SECTION 00 9113
ADDENDUM NUMBER 3

DATE: August 3, 2016

RSMP Phase 2A
James Monroe High School
RFI LOG
8/3/16

DRAWING REFERENCE NUMBER(S): D102
DRAWING NUMBER: ADDSK-A-05
SED CONTROL NUMBERS: SED. #: 26-16-00-01-0-107-029 DWT #: 26-16-00-01-7-999-019

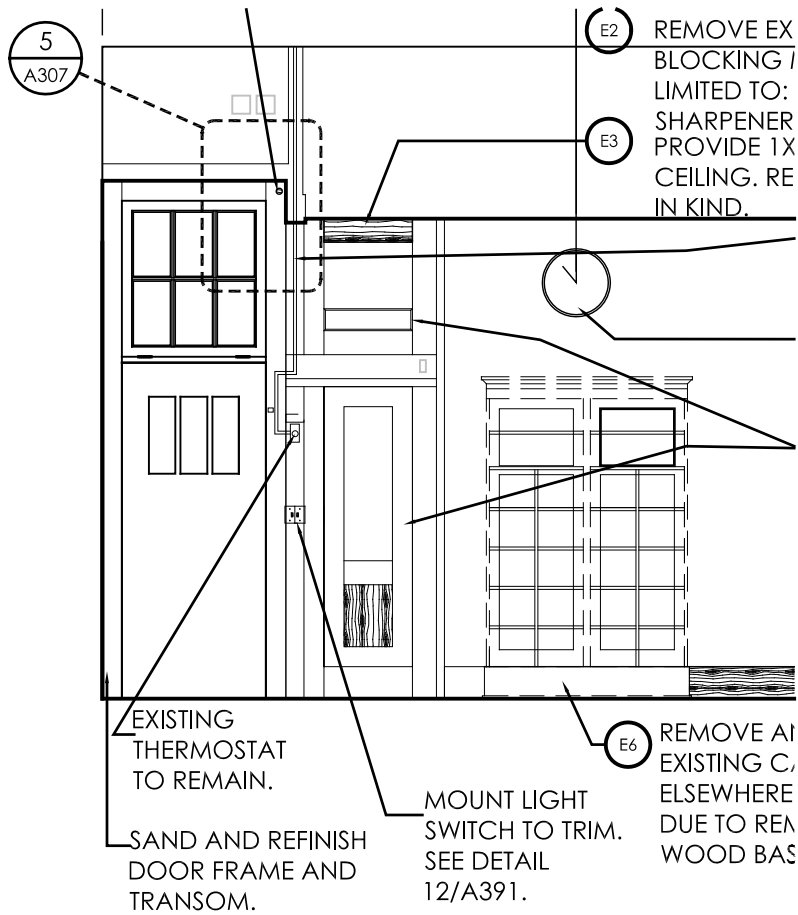
- A. RFI Log, dated 8/3/2016 (3 pages).
- B. Site Walk-through sign in sheet (7/18/2016)
- C. Site Walk-through sign in sheet (7/25/2016)
- D. Section 11 4000 Food Service Equipment
- E. Sketches:
 - ADDSK-A-05 Stair #2 Keynotes
 - ADDSK-A-06 Typical Door Bulkhead Detail
 - ADD3-M1 Additional Chilled Beam Terminal Schedule
 - ADD3-M2 Screening 139 Smoke Damper Plan
 - ADD2-SK-P-01 Partial Basement Plumbing Removal Work
 - ADD2-SK-P-02 Partial Basement Plumbing Plan
 - ADD2-SK-P-03 Partial Third Floor Removal Plan
 - ADD2-SK-P-04 Partial Basement Removal Plan
 - ADD2-SK-P-05 Partial Basement removal Plan
 - ADD2-SK-P-06 Partial Basement Removal Plan
 - ADD2-SK-P-07 Partial Basement Removal Plan
 - ADD2-SK-P-08 Partial Basement Plumbing Plan
- F. Drawings:
 - C001 Site Demolition Plan – (Phase 2A Site Lawn Mowing Area outline)

DRAWING REFERENCE NUMBER(S): A306, A307
DRAWING NUMBER: ADDSK-A-06
SED CONTROL NUMBERS: SED. #: 26-16-00-01-0-107-029 DWT #: 26-16-00-01-7-999-019

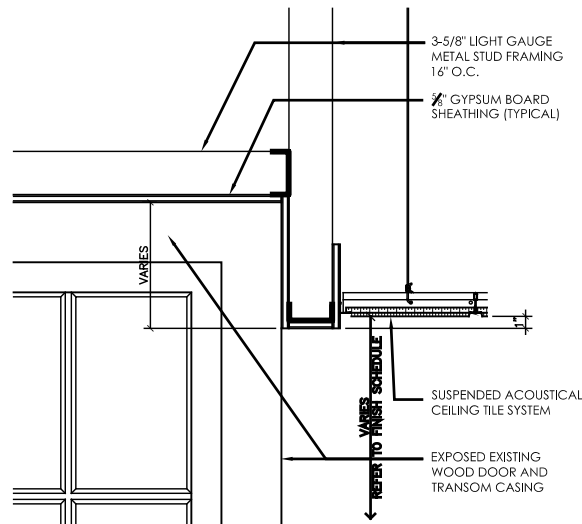
- B. Added detail of typical door bulkhead. Refer to sketch ADDSK-A-06.

DRAWING REFERENCE NUMBER(S): M601
 DRAWING NUMBER: ADD3-M1

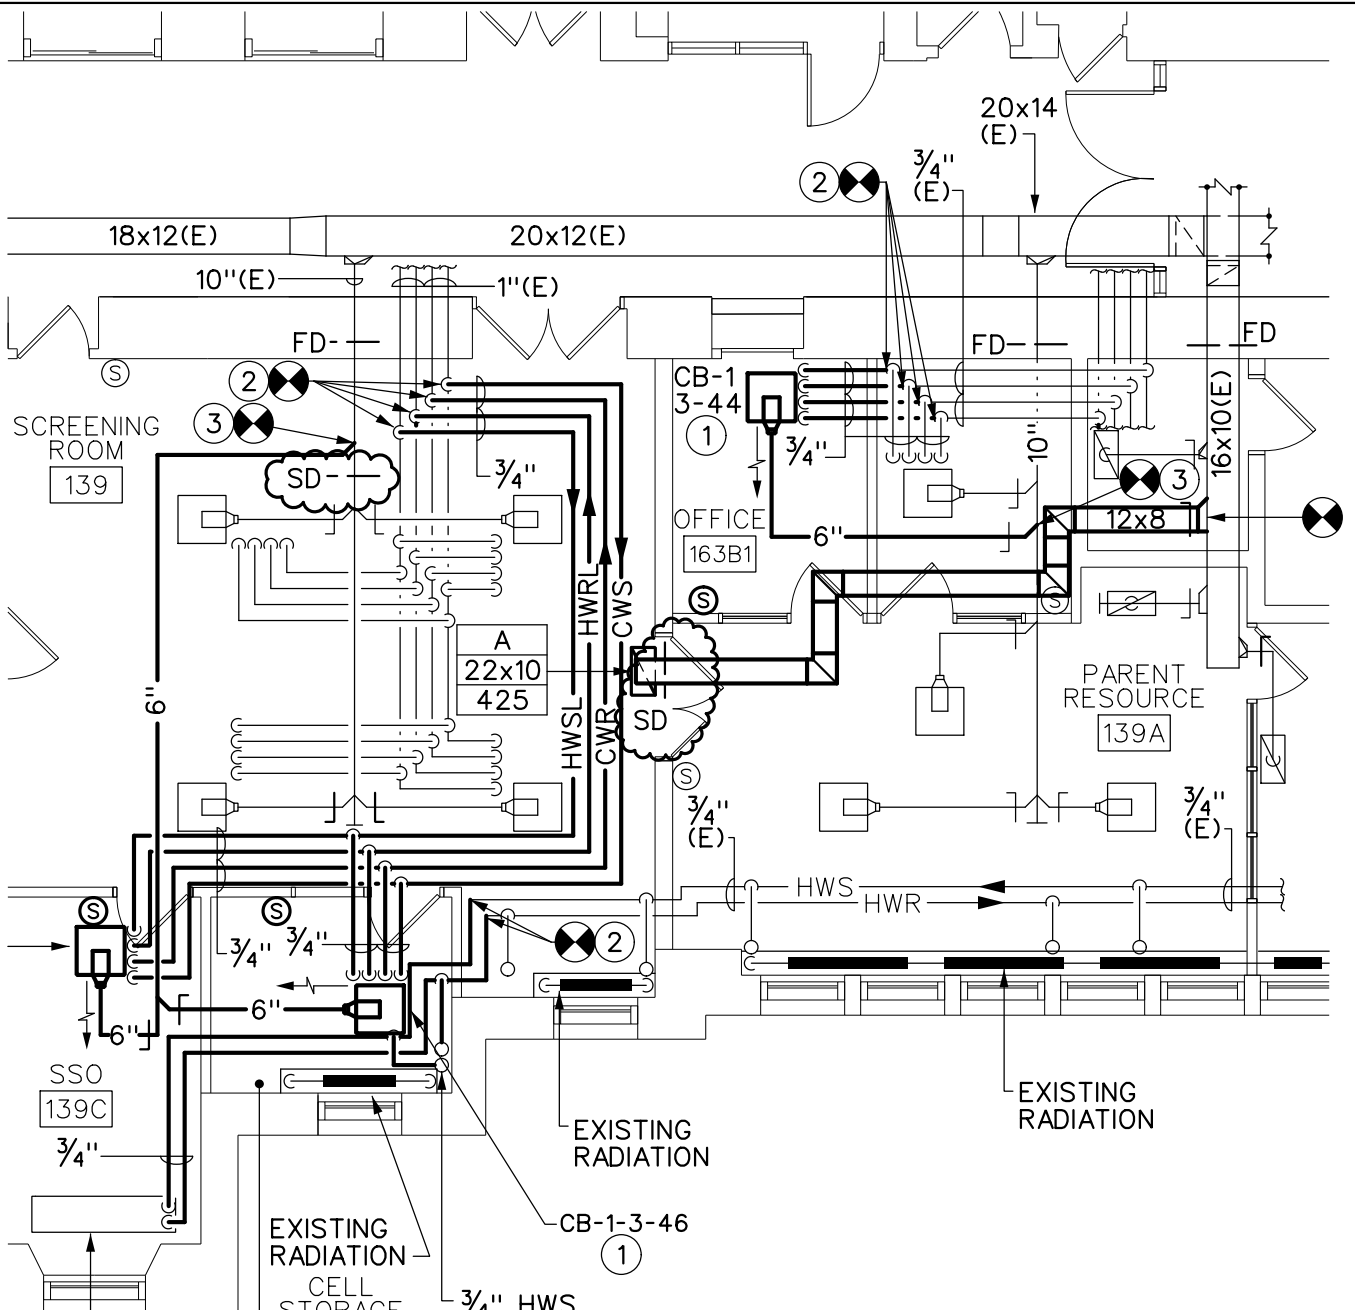
- A. Add the additional chilled beam terminals as indicated on the attached sketch ADD3-M01.

DRAWING REFERENCE NUMBER(S): M-131
DRAWING NUMBER: ADD3-M02
SED CONTROL NUMBERS: SED. #: 26-16-00-01-0-107-029 DWT #: 26-16-00-01-7-999-019

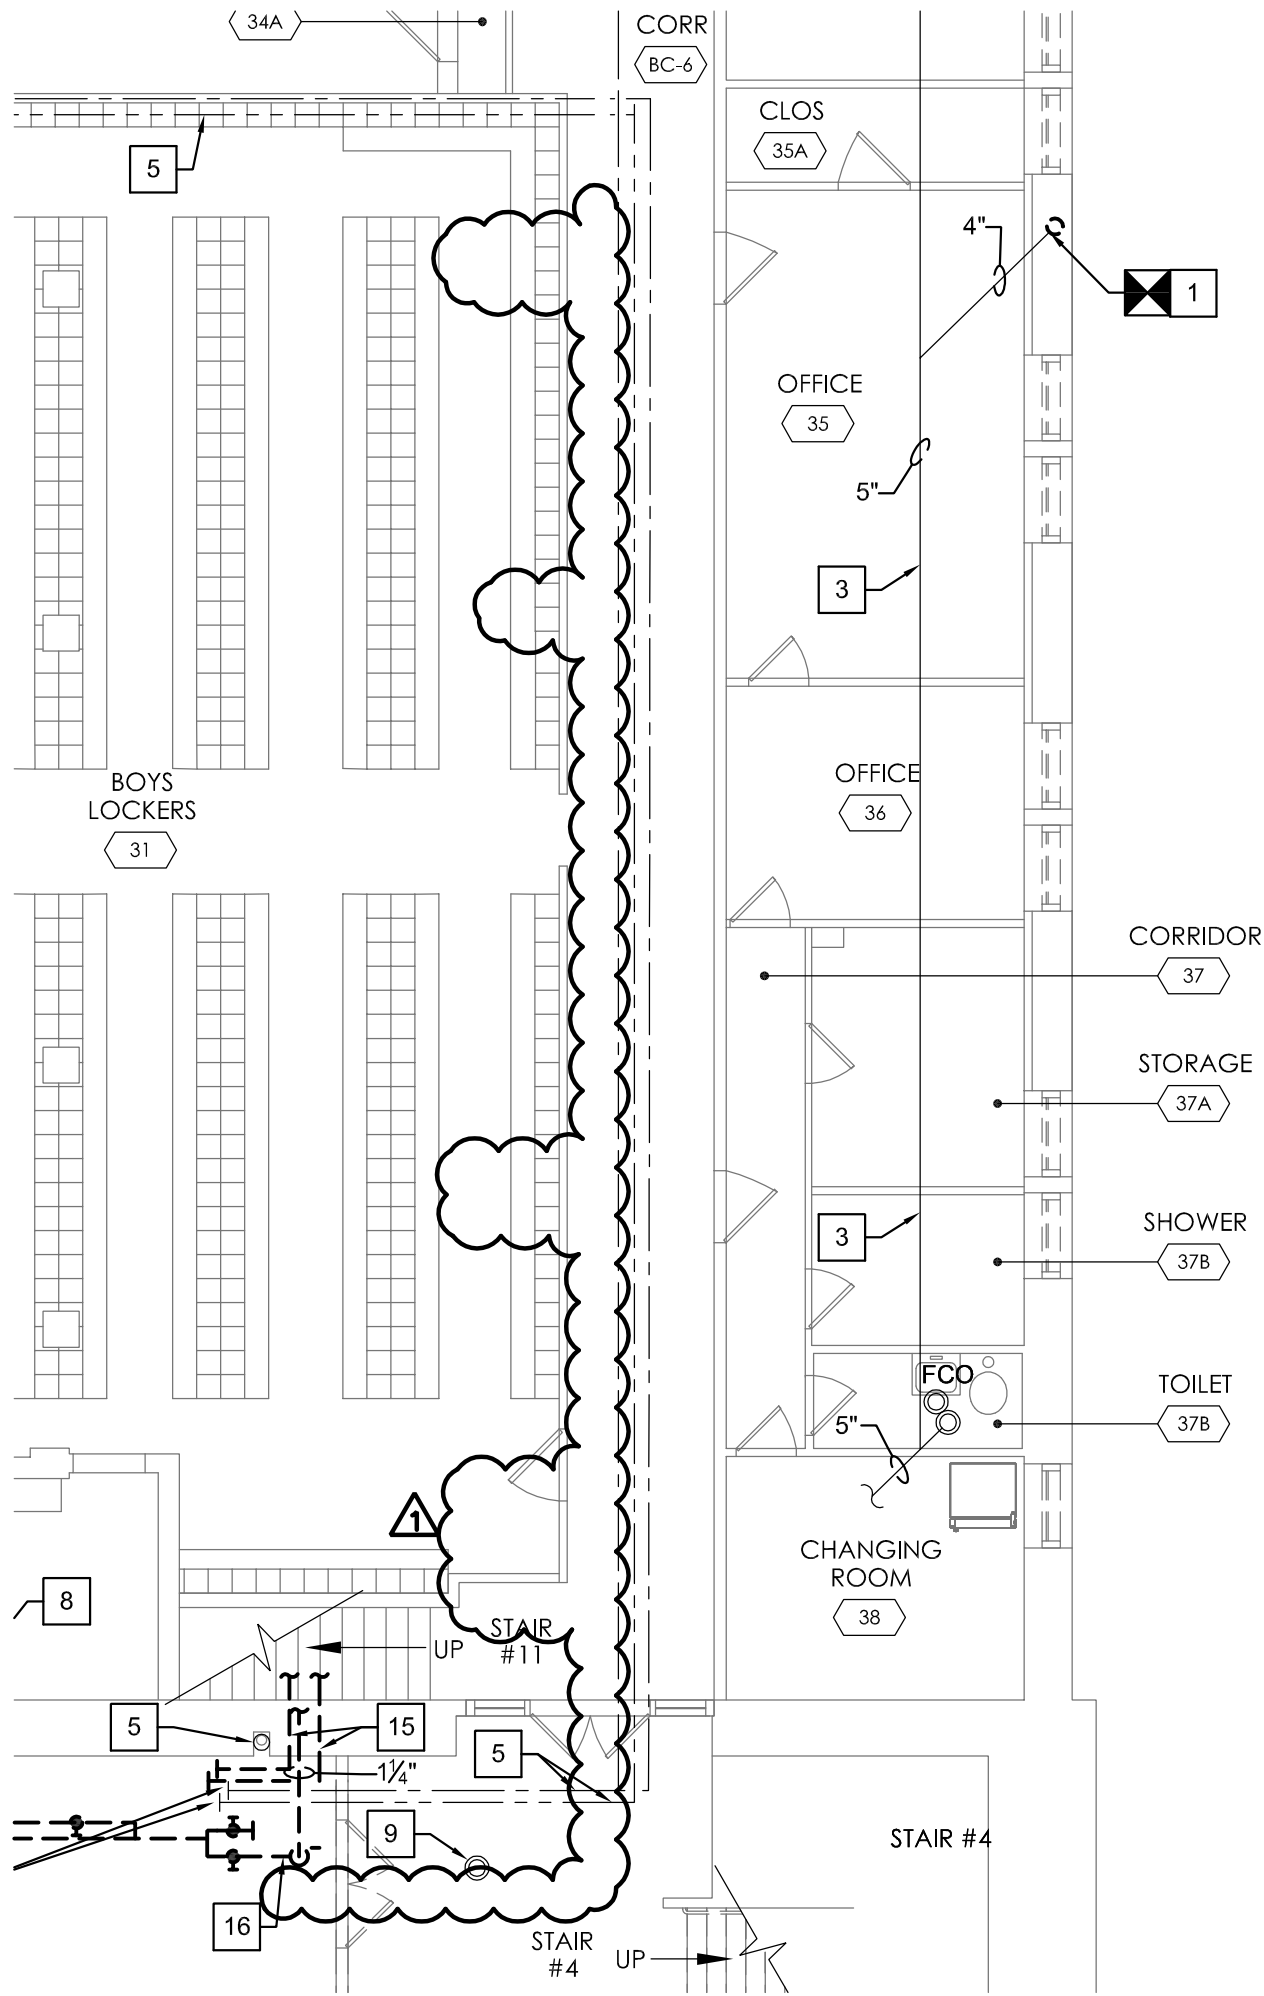
- A. Add the additional smoke dampers to the supply and return ductwork systems feeding Screening Room 139 as indicated on the attached sketch ADD3-M02.

- A. Room 139A: Add one (1) smoke damper on west wall over the double set of doors. Refer to sketch ADD3-M02 for exact location.
- B. Room 139: Add one (1) smoke damper nearest the south wall. Refer to sketch ADD3-M02 for exact location.

DRAWING REFERENCE NUMBER(S): AS NOTED
DRAWING NUMBER: ADD2-SK-P-01

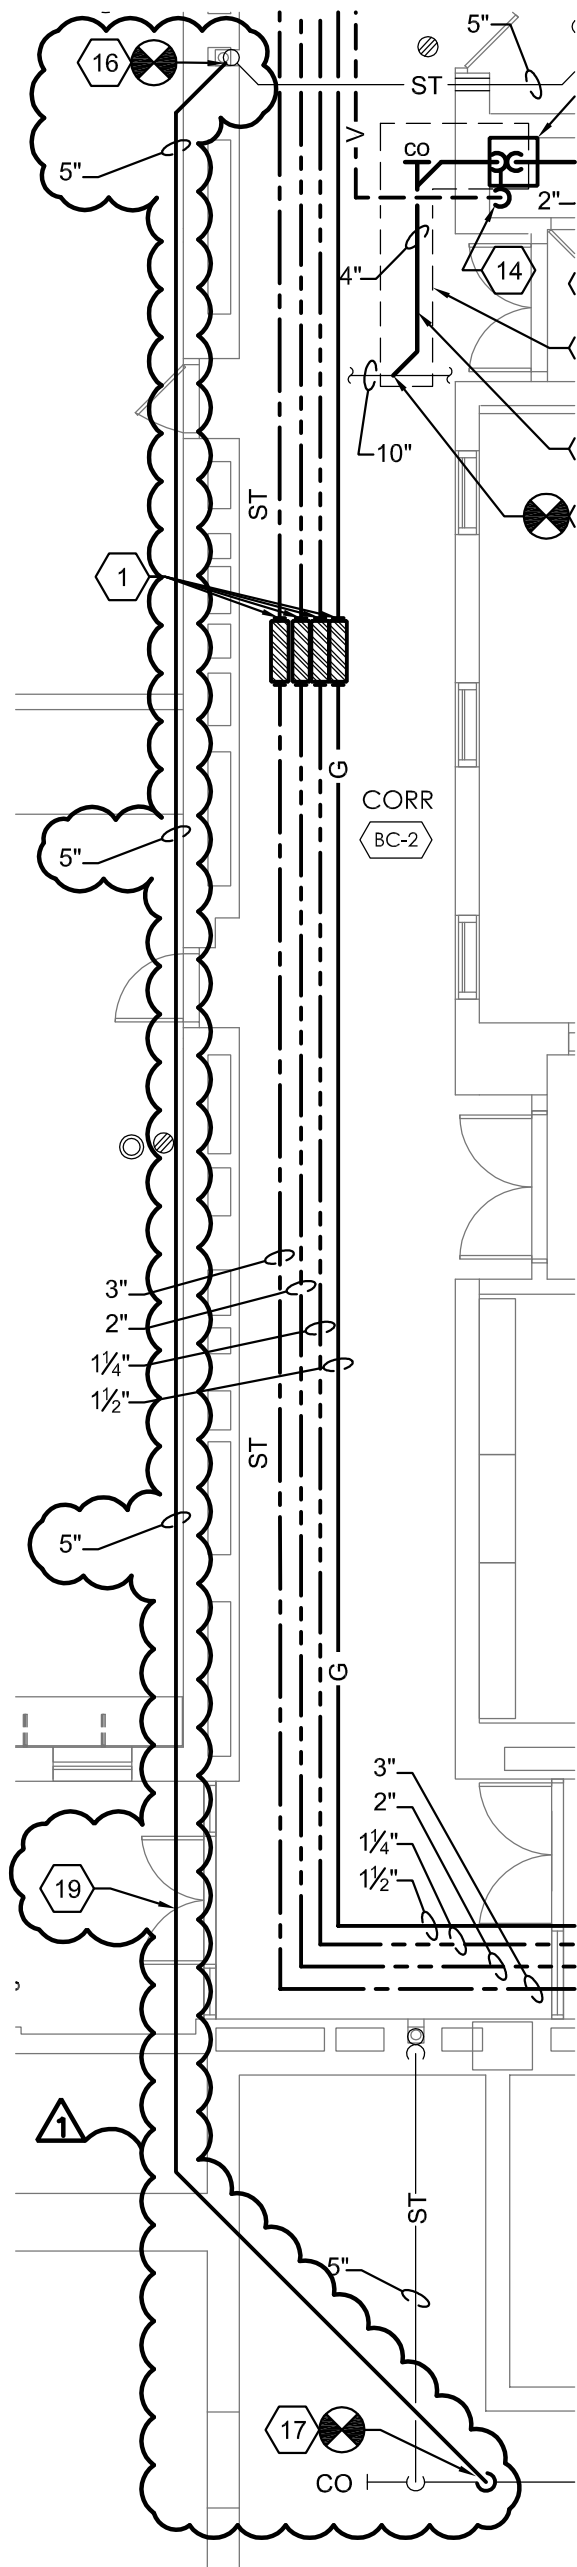
- A. Delete reference to removal of gas piping in corridor. Gas piping was previously removed in Phase 1. "Refer to Sketch ADD2–SK-P-01".

DRAWING REFERENCE NUMBER(S): AS NOTED
DRAWING NUMBER: ADD2-SK-P-02

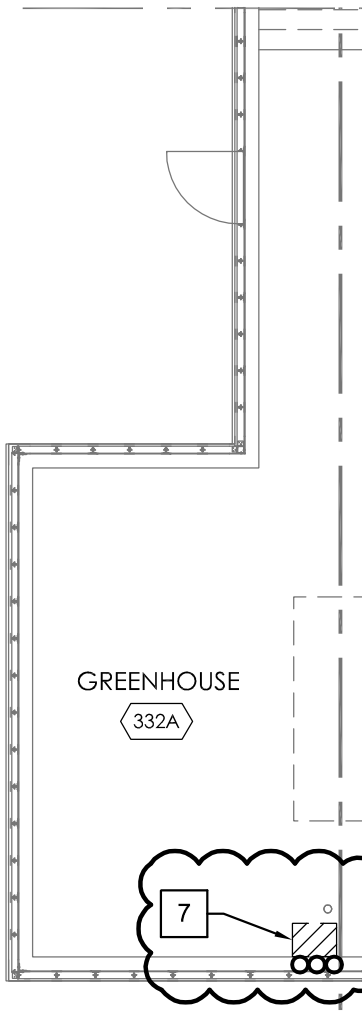
- A. Relocate new 5" storm piping from corridor area as previously shown to over classroom spaces. "Refer to Sketch ADD2–SK-P-02".

DRAWING REFERENCE NUMBER(S): AS NOTED
DRAWING NUMBER: ADD2-SK-P-03
SED CONTROL NUMBERS: SED. #: 26-16-00-01-0-107-029 DWT #: 26-16-00-01-7-999-019

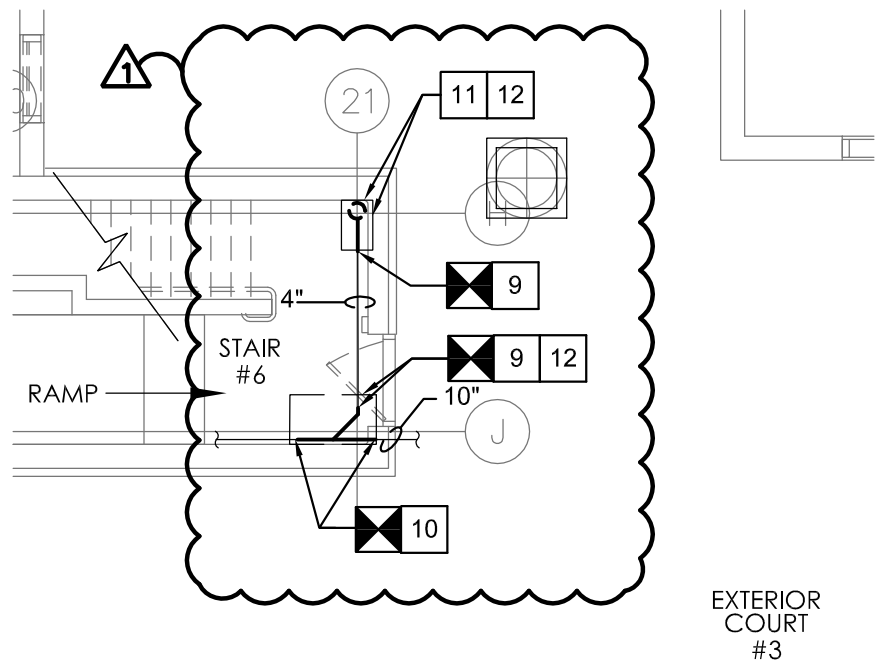
- A. Add removal of existing sink and solids interceptor and accessible branch piping. "Refer to Sketch ADD2–SK-P-03".

DRAWING NUMBER:
ADD2-SK-P-04

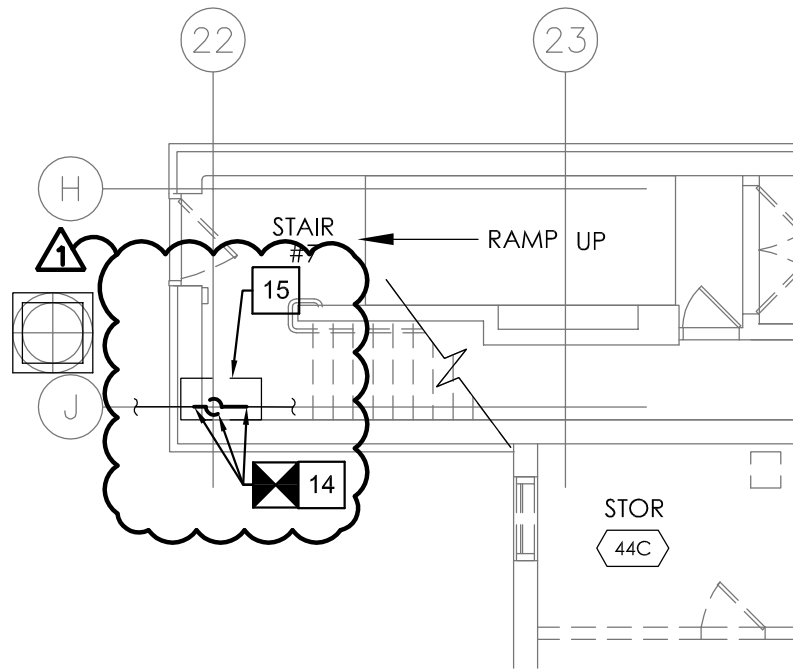
- A. Change and remove below slab storm and sanitary sewer piping locations at columns 21h and 21J. "Refer to Sketch ADD2–SK-P-04".

DRAWING REFERENCE NUMBER(S): AS NOTED
DRAWING NUMBER: ADD2-SK-P-05

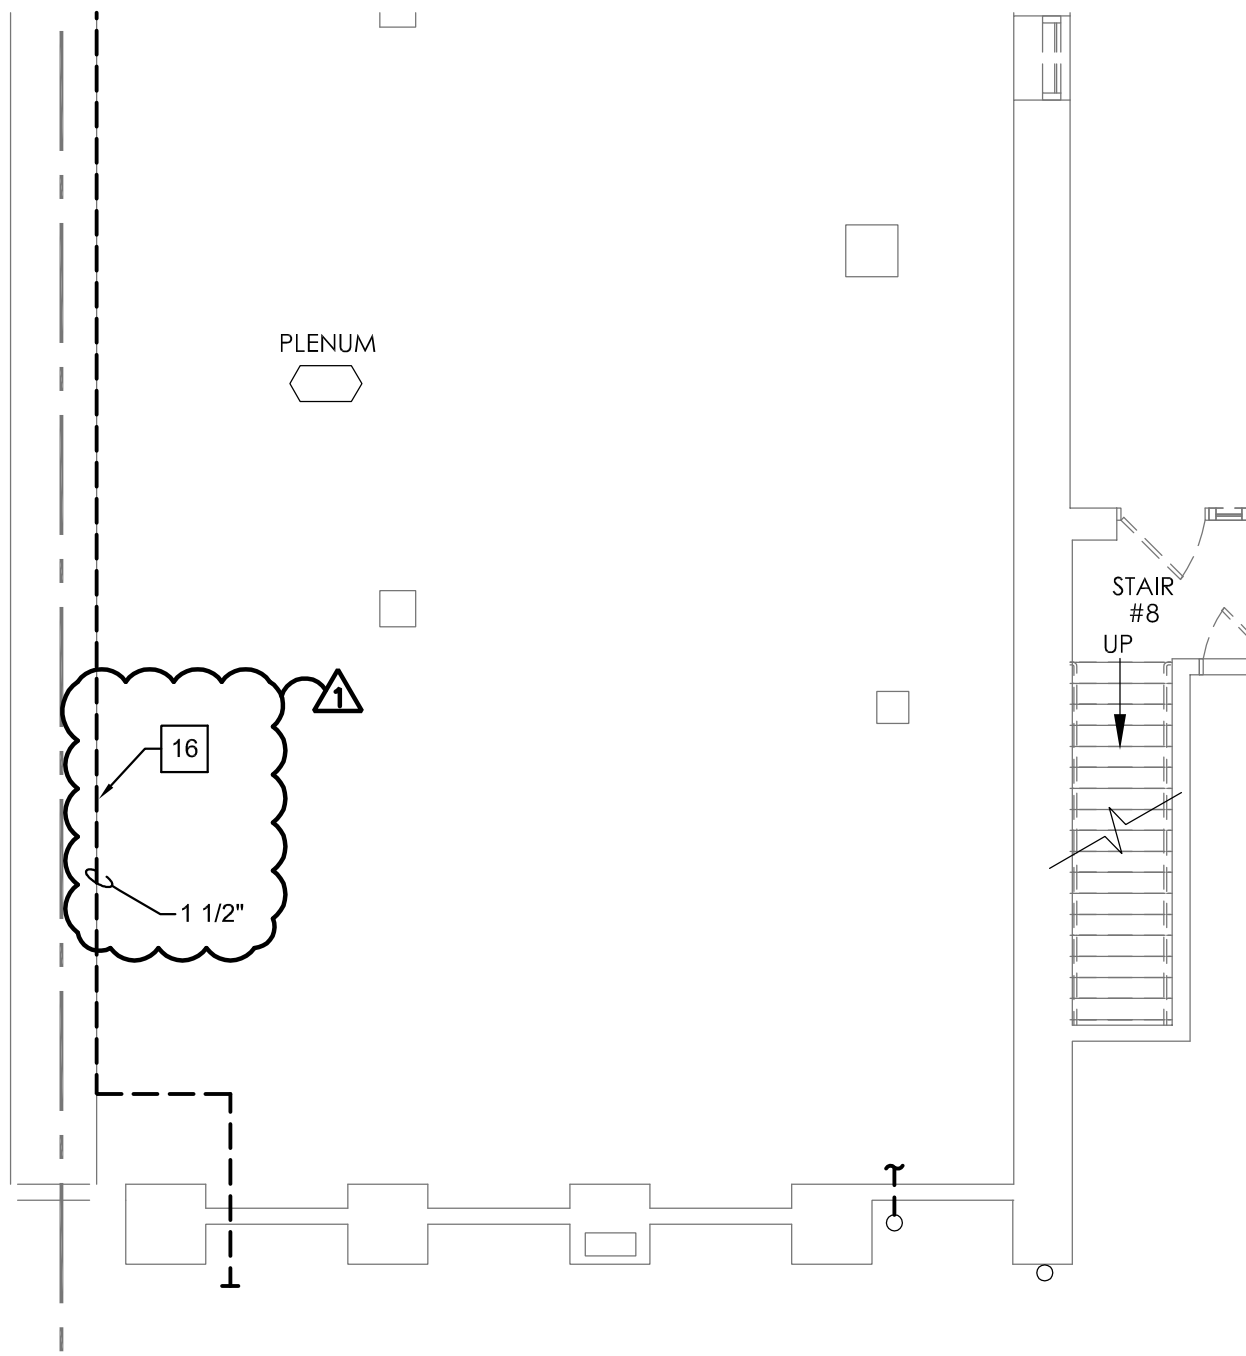
- A. Change and remove below slab storm and sanitary sewer piping locations at columns 22H and 22J Add removal of existing sink and solids interceptor and accessible branch piping. "Refer to Sketch ADD2–SK-P-05".

DRAWING REFERENCE NUMBER(S): AS NOTED
DRAWING NUMBER: ADD2-SK-P-06

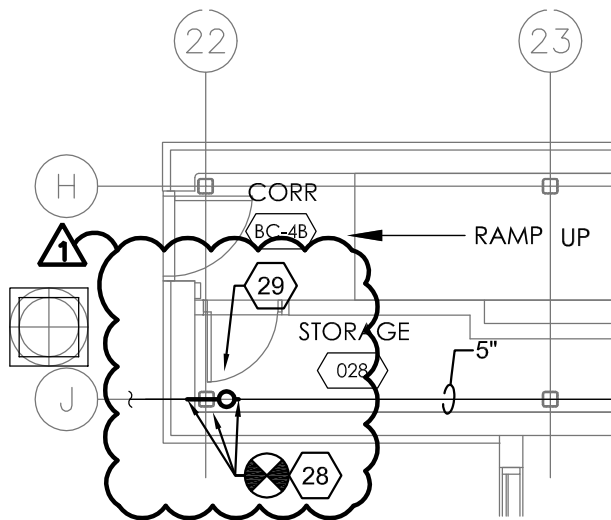
- A. Add removal of abandoned 1-1/2 inch domestic hot water recirculation branch piping below auditorium. "Refer to Sketch ADD2–SK-P-06".
